**KEY WEST HISTORIC SEAPORT  
PHASE ONE  
KEY WEST, FLORIDA**

**ADDENDUM NO. 1**

*February 17, 2015*

HISTORIC SEAPORT HARBORWALK - AREA #5 (PROPOSED)

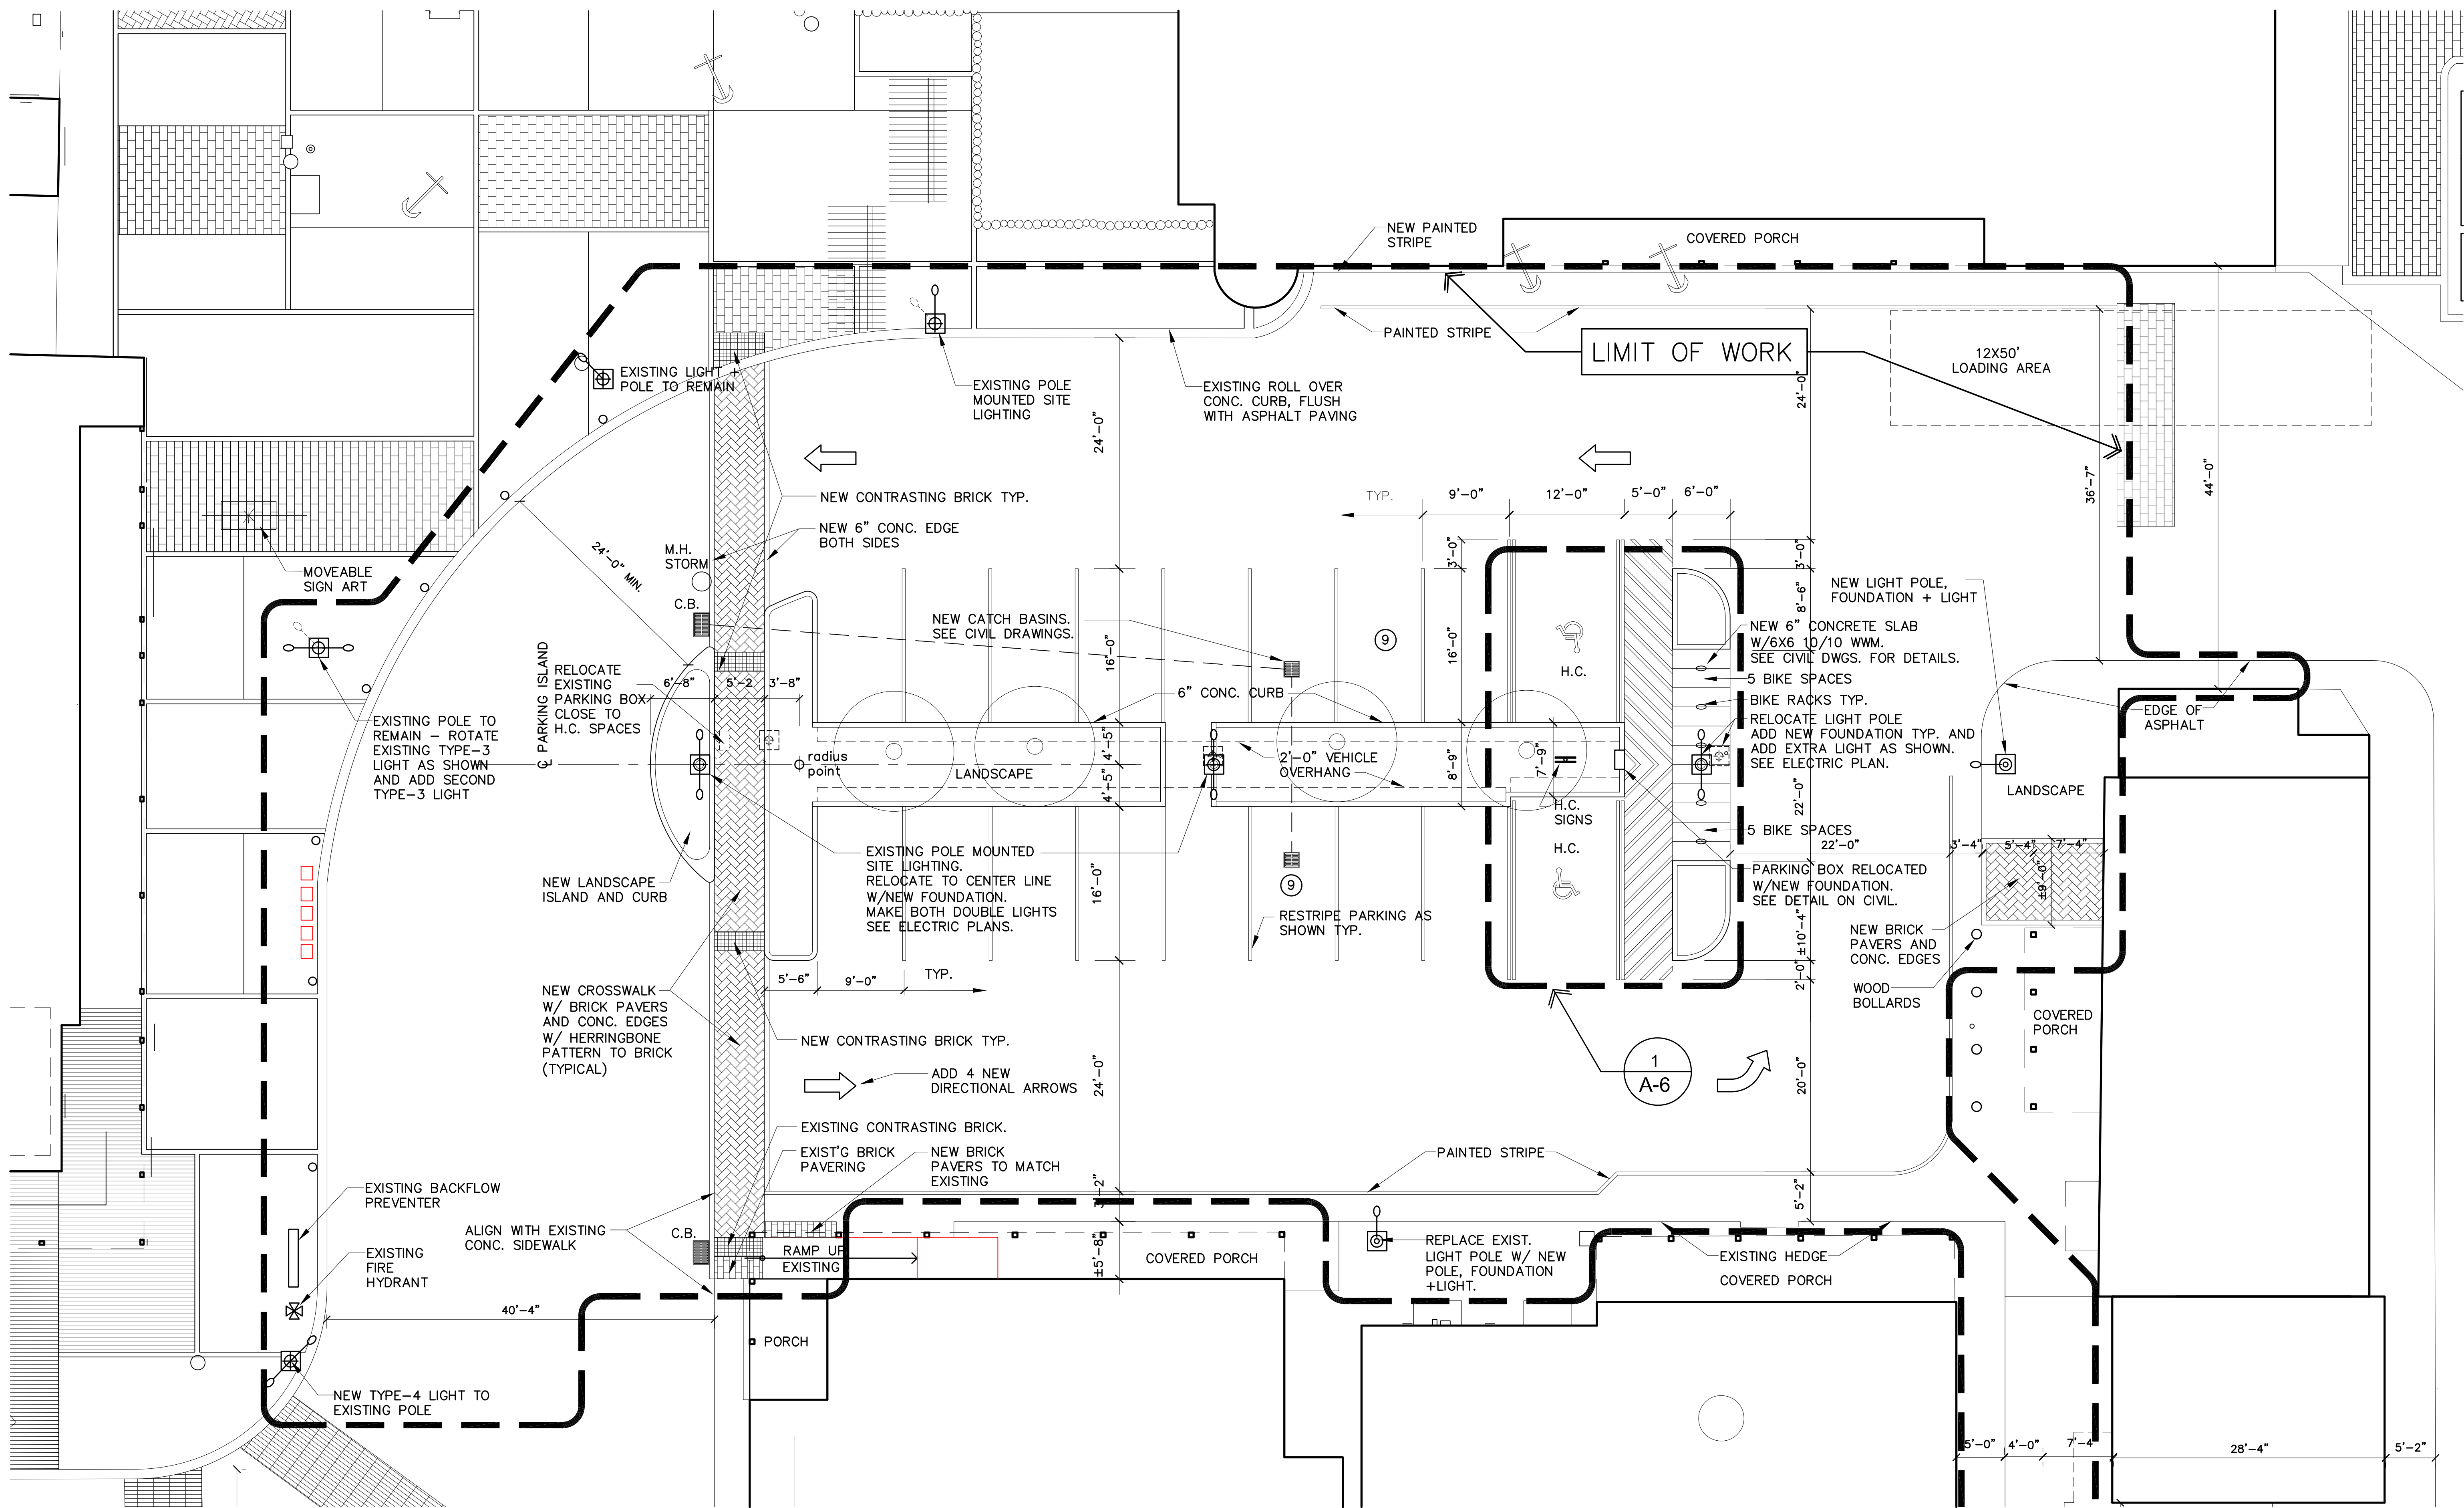
24. It was discussed to seal coat the existing asphalt once all work is complete. Please provide the extents of seal coating.

**Provide price to seal coat the entire parking lot of Area 5 (within the limit of work area shown on revised sheet A-4. Include within this price 4 direction arrows (shown on revised A-4) and restriping all existing striping being covered over by seal coat (including loading zone, fire lanes and other existing striping).**

DECK FRAMING PLAN - AREA 1

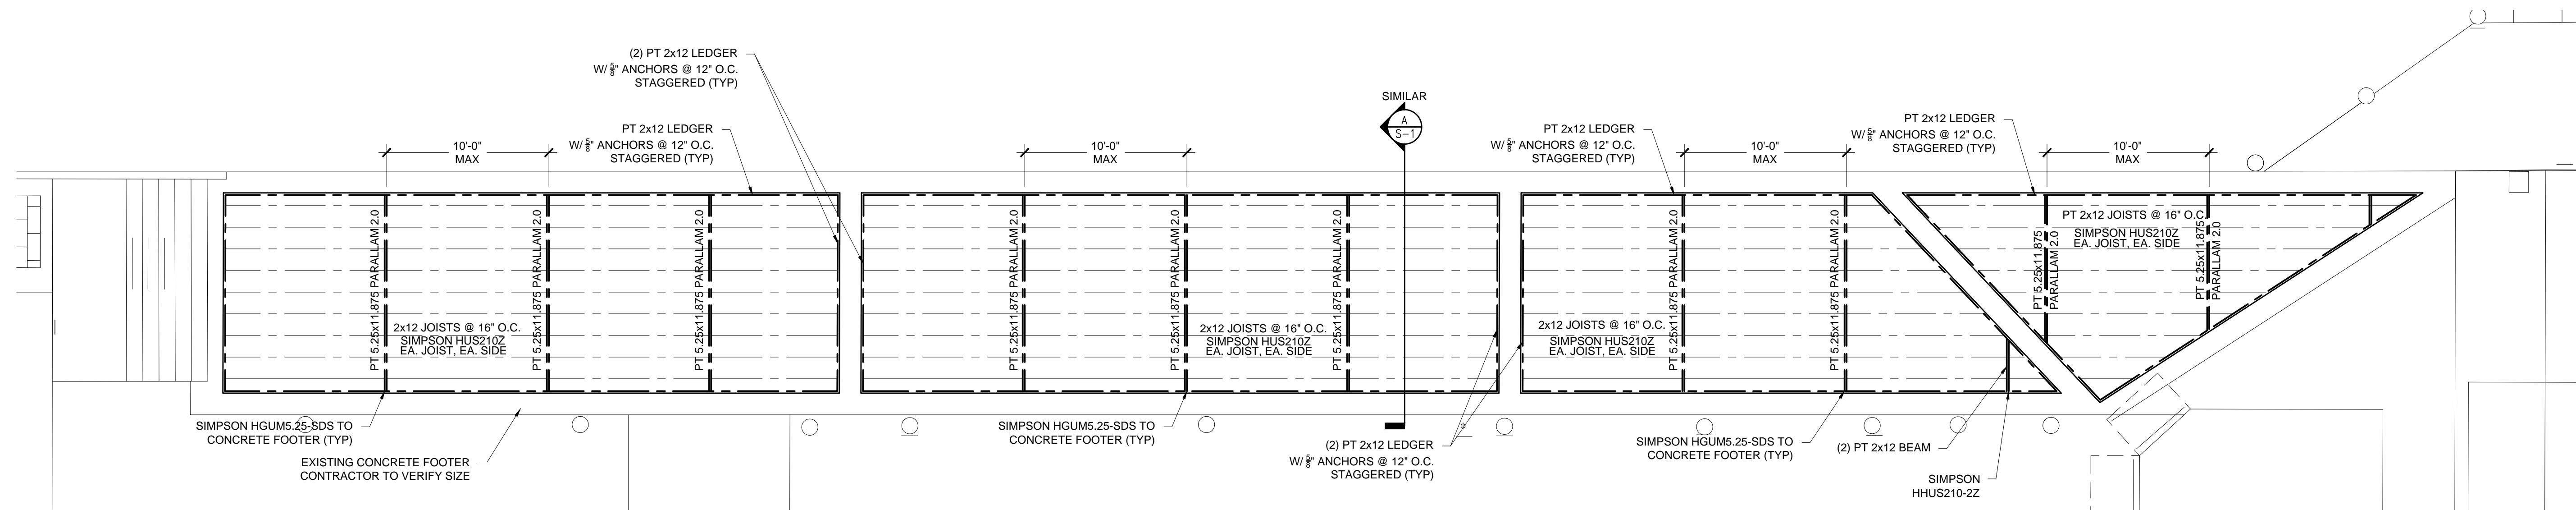
10. The existing wood ramp for the bathrooms at area 3 has concrete footers poured over the existing brick pavers. The Deck Framing Plan at Area 1 on Sheet S-1 shows a new "12x24" grade beam" which will be poured against these pavers. We are concerned the wood ramp / footers will undermine during the installation of this grade beam. Also, due to the 3' thick layer of #57 stone, the trench will be 5' below these footers. Please advise.

13. Please advise if detail A S-1 is to be used at the Deck Framing Plan – Area 1 on sheet S-1. Currently this detail is not indicated in Area 1.

**See Revised S-1 for new section cut and shallower trench. Contractor to shore/support adjacent structures and appurtenances as necessary to build to construction documents.**

**Yes it will be used in Area 1.**

DECK FRAMING PLAN - AREA 3

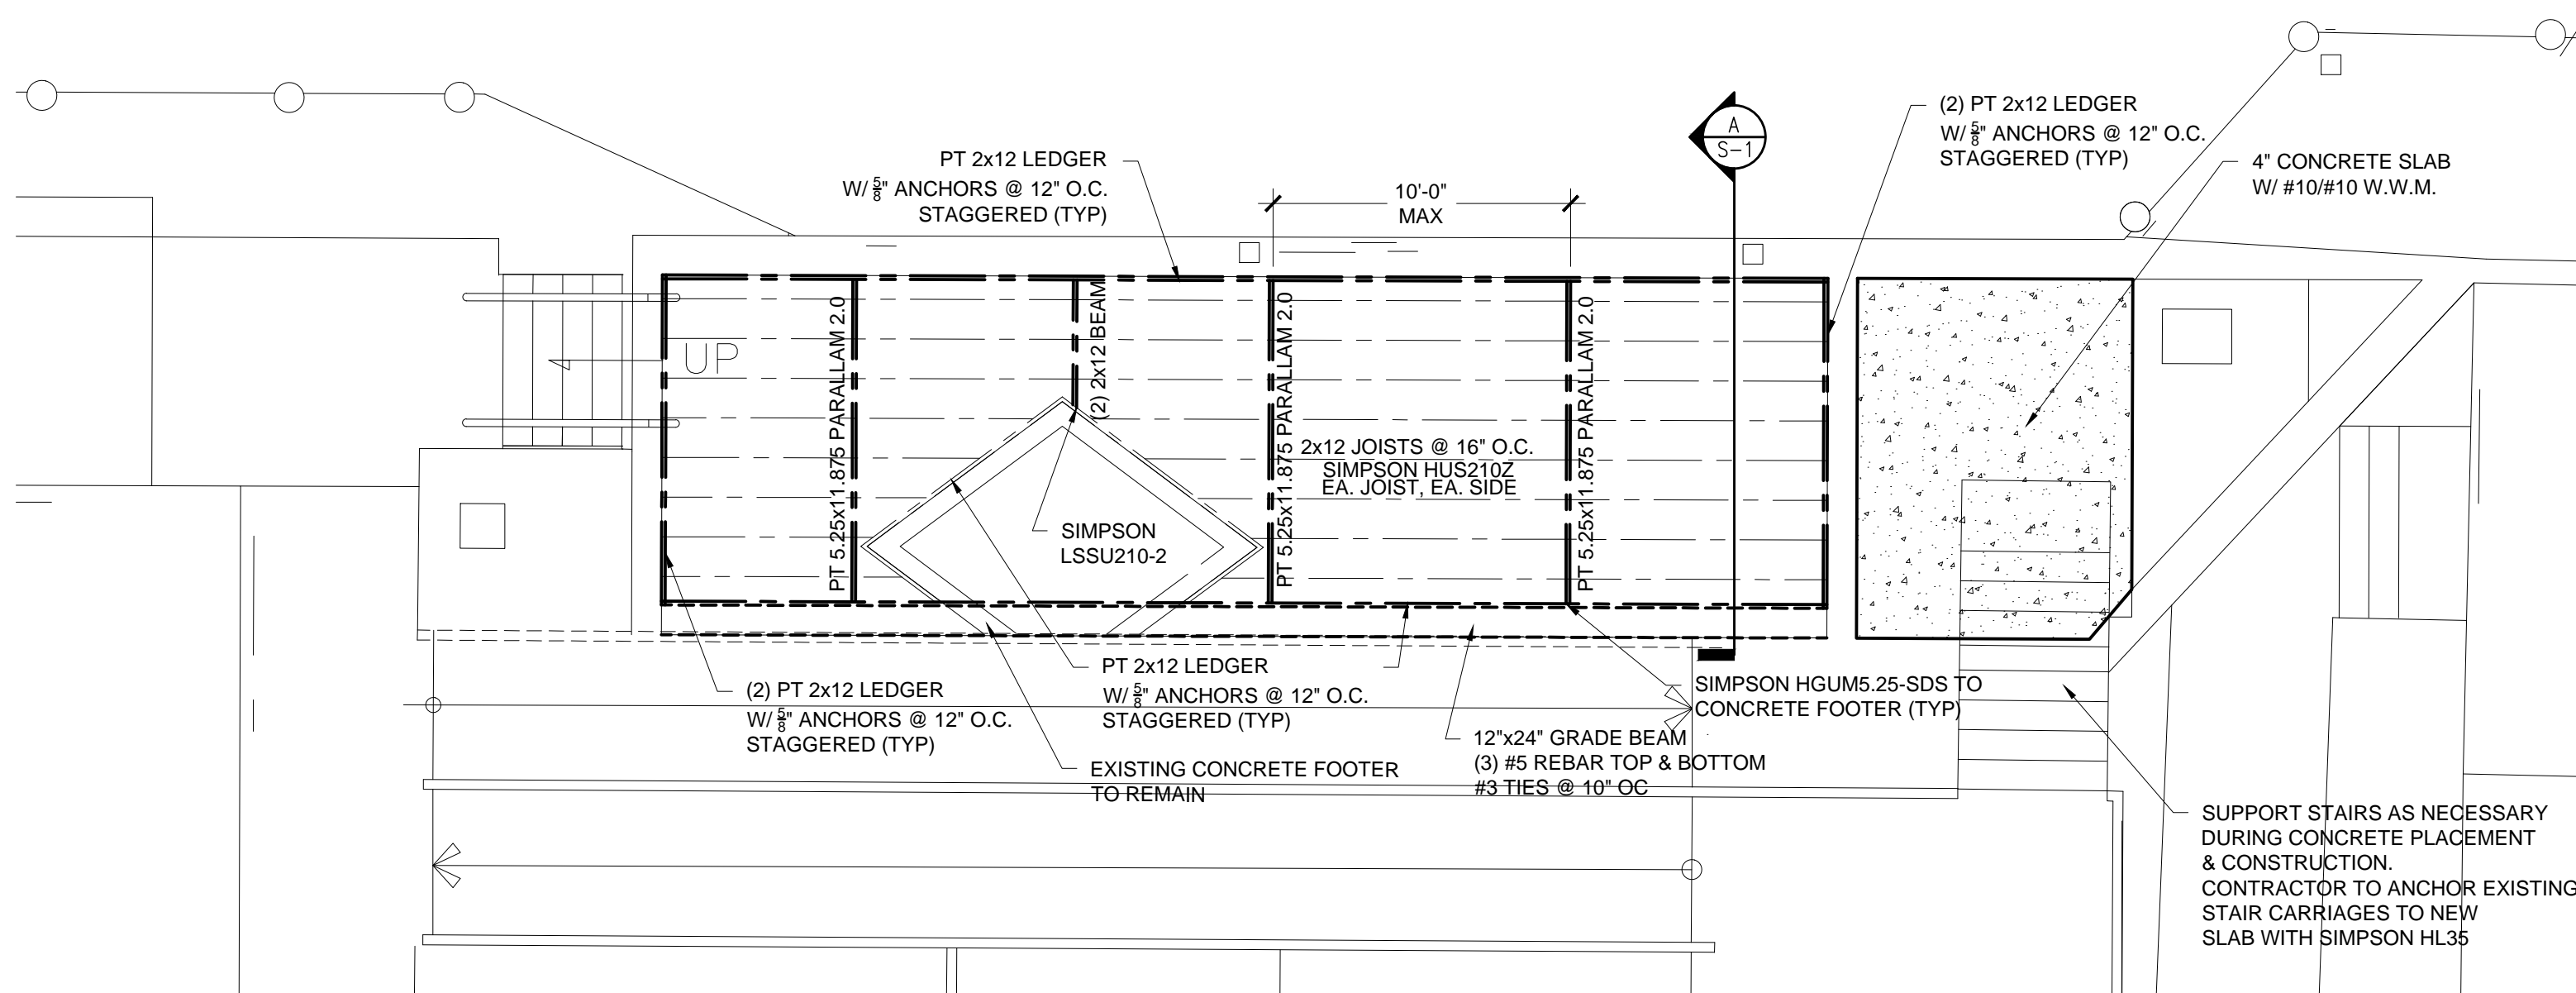
9. Sheet A-2 - Areas #3 shows new Ipe decking under the existing stairs. Sheet S-1 - Area 3 does NOT show any framing in this location. Please advise.

**Area revised to show concrete slab in area described above. See Revised S-1**

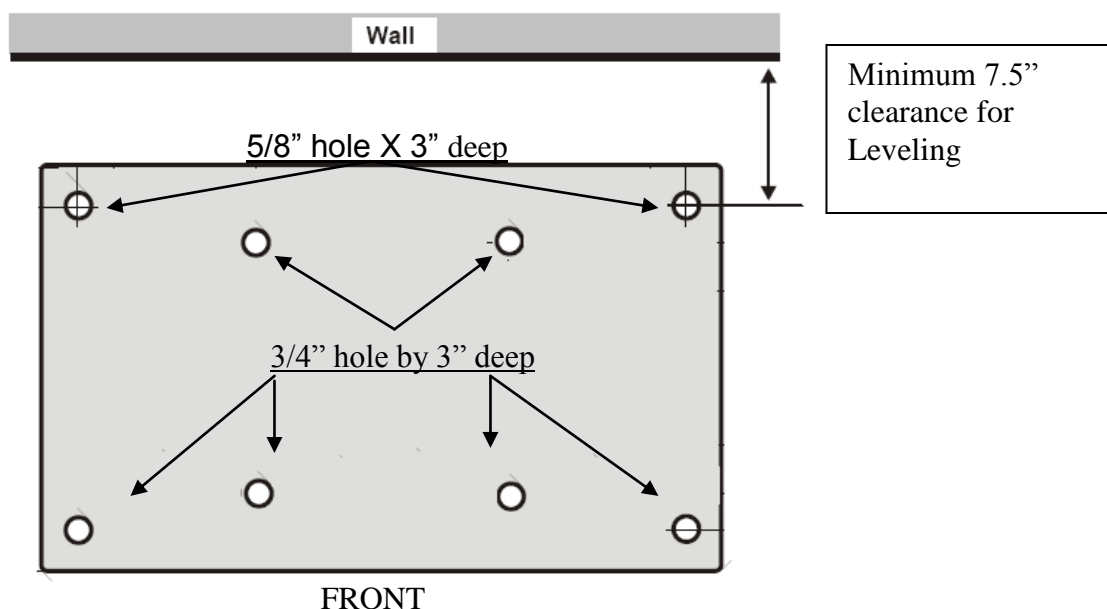
22. Sheet C-3 detail 11 Pay Station Base/Anchor. Please a specification and dimensions, material, manufacture etc. There is not sufficient information in this detail.

**The manufacturer is Cale America ([www.caleamerica.com](http://www.caleamerica.com), I-877-620-2253). See attached cut sheets of base.**

MOUNTING / HARDWARE DETAIL

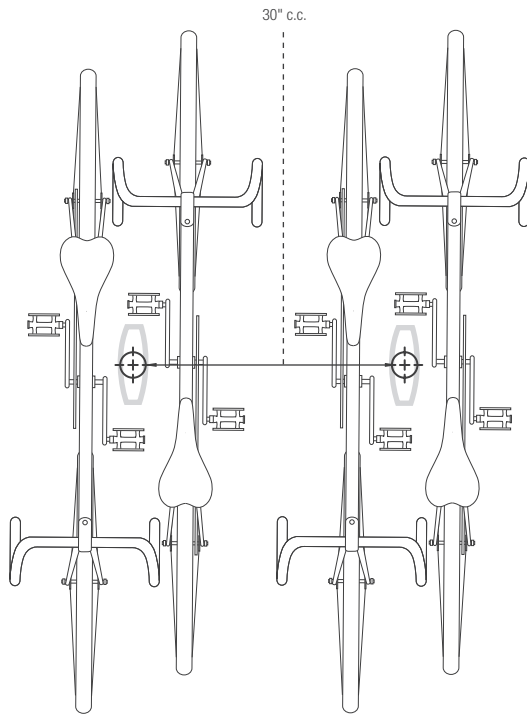
27. **Contractor shall purchase and install 15 bike racks to be located in the field. This will include all anchorage hardware (stainless steel) and a 16”x16”x16” concrete foundation base (if placed individually). Add this cost in the bid form miscellaneous line items.**

**See attached photo/ cut sheet of bike rack.**
